REMARKS

AMENDMENTS TO THE DRAWINGS

Application No.: 10/055,970
Amendment dated November 3, 2003
Reply to Office Action of October 6, 2003
Annotated Sheet Showing Changes

FIG. 1

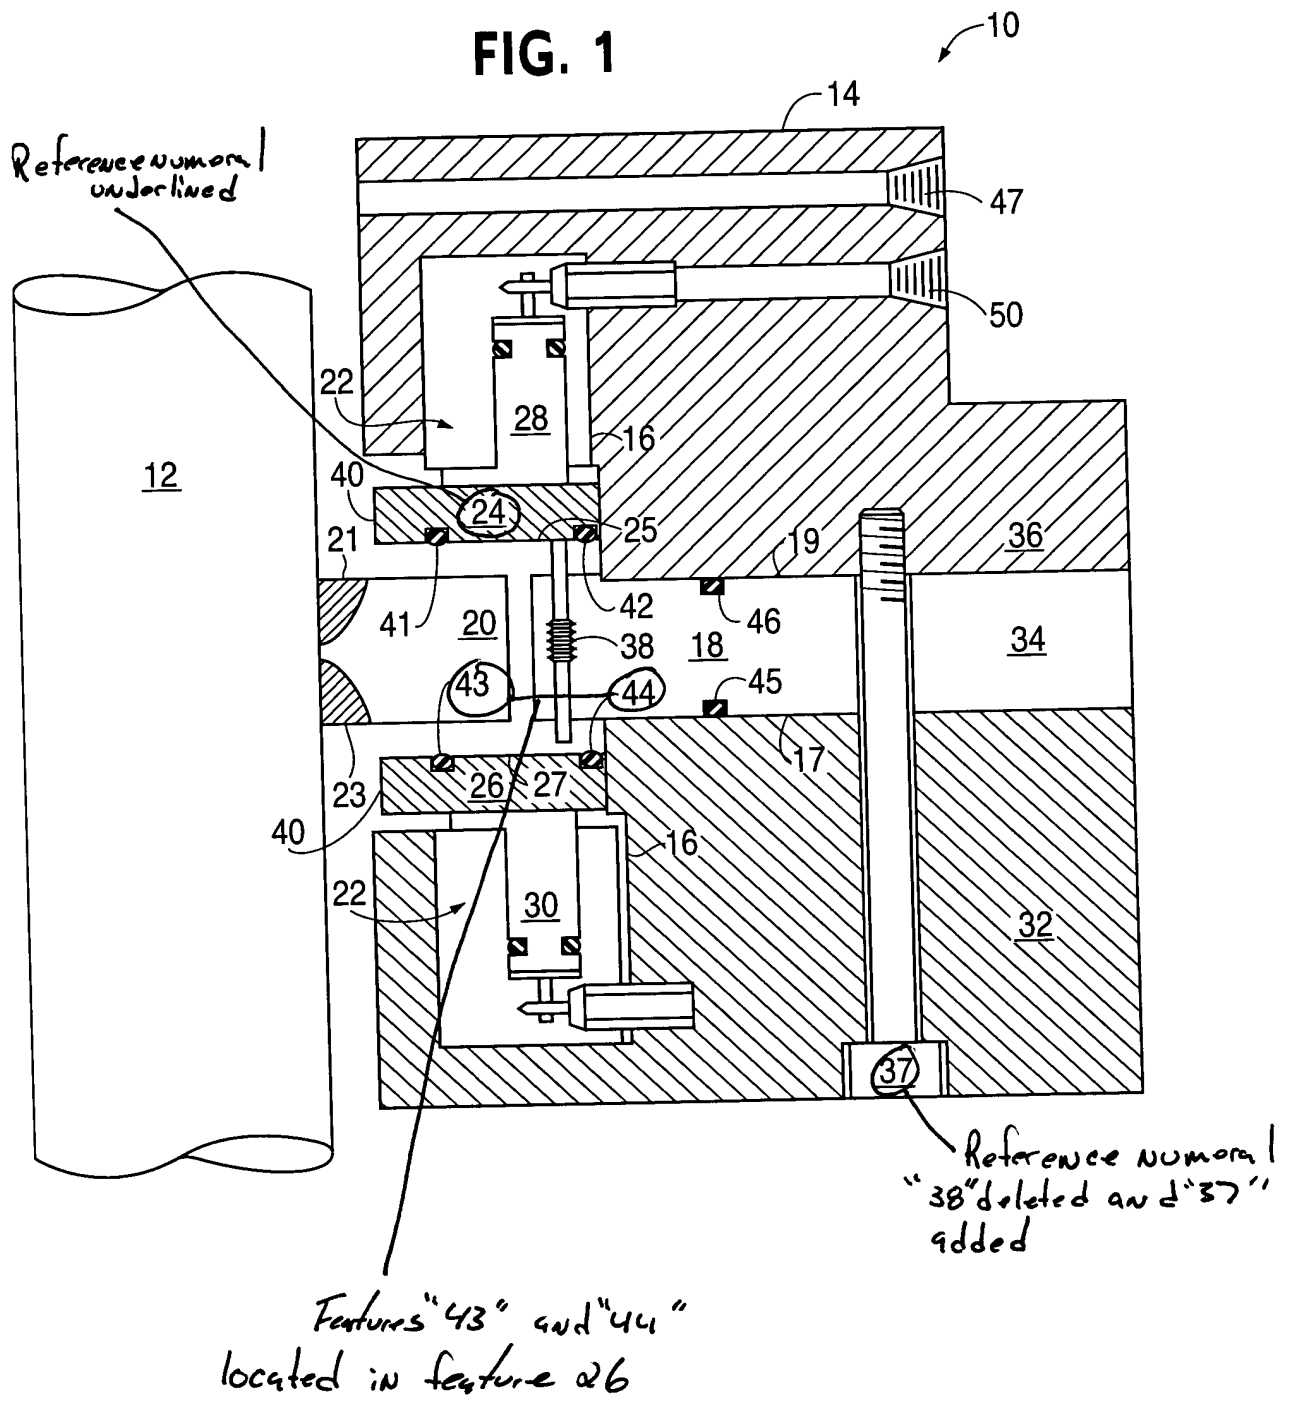
Applicant has amended the FIGS. 1 and 2 to add reference numeral 37 which now designates the bolt. FIGS. 1 and 2 have been further amended so that reference numeral "24" is underlined as requested by the Examiner. FIG. 1 has been additionally amended to illustrate the features designated by reference numerals 43 and 44 to be located in the moveable element 26. FIG. 6 has been amended so that reference numeral "200" includes a lead line as requested by the Examiner. These amendments are in accordance with 37 C.F.R. 1.84 and are reflected in the Replacement Sheets submitted herewith.

Reference numbers /
underlined
